Contract #: 04-0120F4Cty: SF/ALA Rte: 80 PM: 13.2/13.9File #: 69.25B**QUALITY ASSURANCE -- NON-CONFORMANCE REPORT****Location:** Changxing Island, Shanghai, PR China**Report No:** NCR-000789**Prime Contractor:** American Bridge/Fluor Enterprises, a JV**Date:** 06-Jul-2010**Submitting Contractor:** Zhenhua Port Machinery Company, Ltd (ZPMC), Changxing Island**NCR #:** ZPMC-0751**Type of problem:**

Bridge No: 34-0006**Component:** Grillage Internal Stiffeners, Lift 5, East Tower**Reference Description:** Insufficient Preheat for Welding**Description of Non-Conformance:**

Subject: NCR No. ZPMC-0751

Reference Description: Insufficient Preheat for Welding/Tower/East/Lift 5 Internal Stiffeners

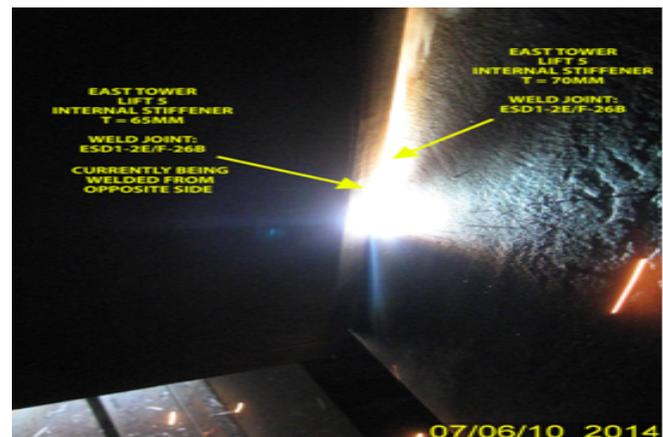
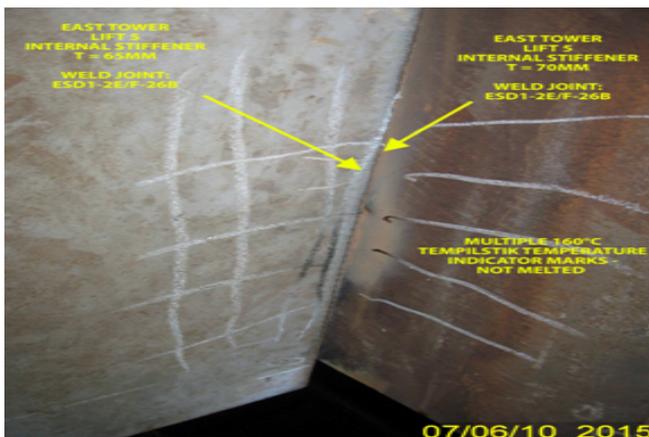
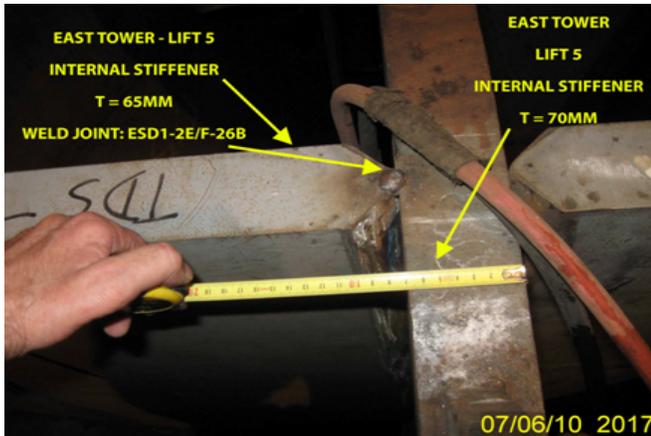
Caltrans Quality Assurance (QA) Inspector observed ZPMC personnel performing Shielded Metal Arc tack Welding (SMAW) of weld joint ESD1-TL5-2E/F-26B, 65mm to 70mm grillage internal stiffeners located inside East Tower, Lift 5, approximately 300mm from bottom of Lift 5, without sufficient base material preheat as follows:

- Multiple 160°C Tempilstik temperature indicator marks applied by this QA Inspector to the adjacent base material within approximately 40mm from the point of welding did not melt.
- East Tower, Lift 5, is designated as A709M, HPS 485W-T2. WPS-B-T-3213-TC-U5b requires the minimum preheat and interpass temperature to be 160°C for material thickness more than 60mm.

Refer to photos below for additional information.

AWS D1.5 (2002), Section 4.2.7 requires the base metal material to be at or above the specified minimum temperature for a distance not less than 75mm in all directions from the point of welding.

This proposed resolution is accepted with action pending. This NCR will be considered closed once the proper NDT documentation is submitted and reviewed.

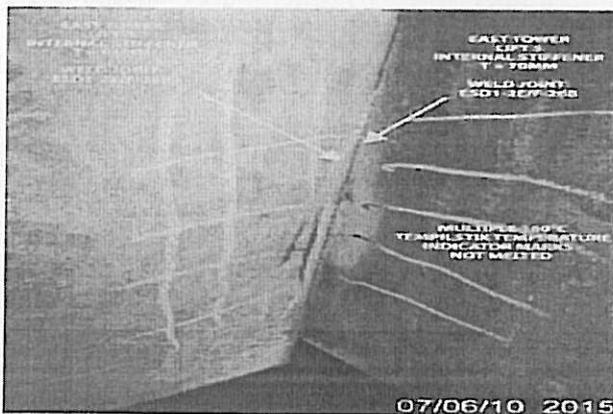
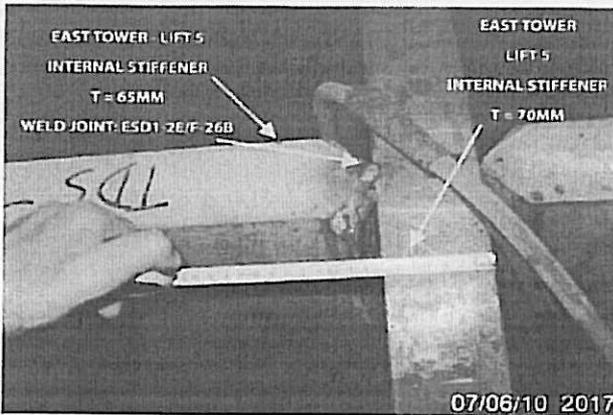
Caltrans Quality Assurance (QA) Inspector observed ZPMC personnel performing Shielded Metal Arc tack Welding (SMAW) of weld joint ESD1-TL5-2E/F-26B, 65mm to 70mm grillage internal stiffeners located inside East Tower, Lift 5, approximately 300mm from bottom of Lift 5, without sufficient base material preheat as follows:

- Multiple 160°C Tempilstik temperature indicator marks applied by this QA Inspector to the adjacent base material within approximately 40mm from the point of welding did not melt.

- East Tower, Lift 5, is designated as A709M, HPS 485W-T2. WPS-B-T-3213-TC-U5b requires the minimum preheat and interpass temperature to be 160°C for material thickness more than 60mm.

Refer to photos below for additional information.

AWS D1.5 (2002), Section 4.2.7 requires the base metal material to be at or above the specified minimum temperature for a distance not less than 75mm in all directions from the point of welding.

This proposed resolution is acceptable. The documentation received is sufficient and the Department concurs that Non-Conformance ZPMC-0751 is closed.

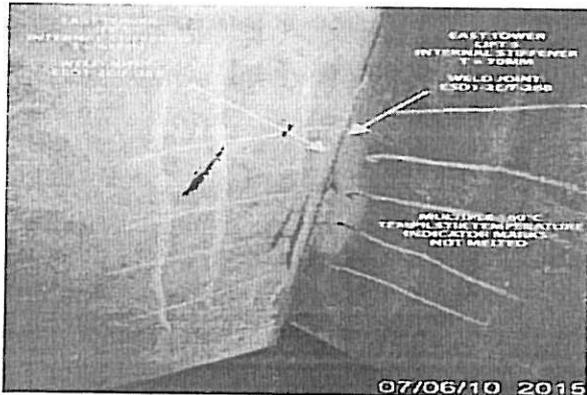
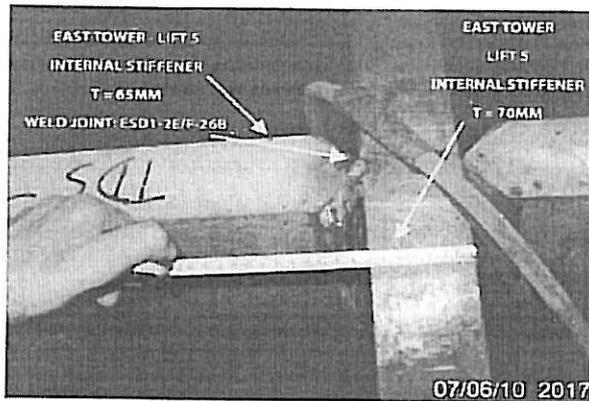
Caltrans Quality Assurance (QA) Inspector observed ZPMC personnel performing Shielded Metal Arc tack Welding (SMAW) of weld joint ESD1-TL5-2E/F-26B, 65mm to 70mm grillage internal stiffeners located inside East Tower, Lift 5, approximately 300mm from bottom of Lift 5, without sufficient base material preheat as follows:

- Multiple 160°C Tempilstik temperature indicator marks applied by this QA Inspector to the adjacent base material within approximately 40mm from the point of welding did not melt.
- East Tower, Lift 5, is designated as A709M, HPS 485W-T2. WPS-B-T-3213-TC-U5b requires the minimum preheat and interpass temperature to be 160°C for material thickness more than 60mm.

Refer to photos below for additional information.

AWS D1.5 (2002), Section 4.2.7 requires the base metal material to be at or above the specified minimum temperature for a distance not less than 75mm in all directions from the point of welding.
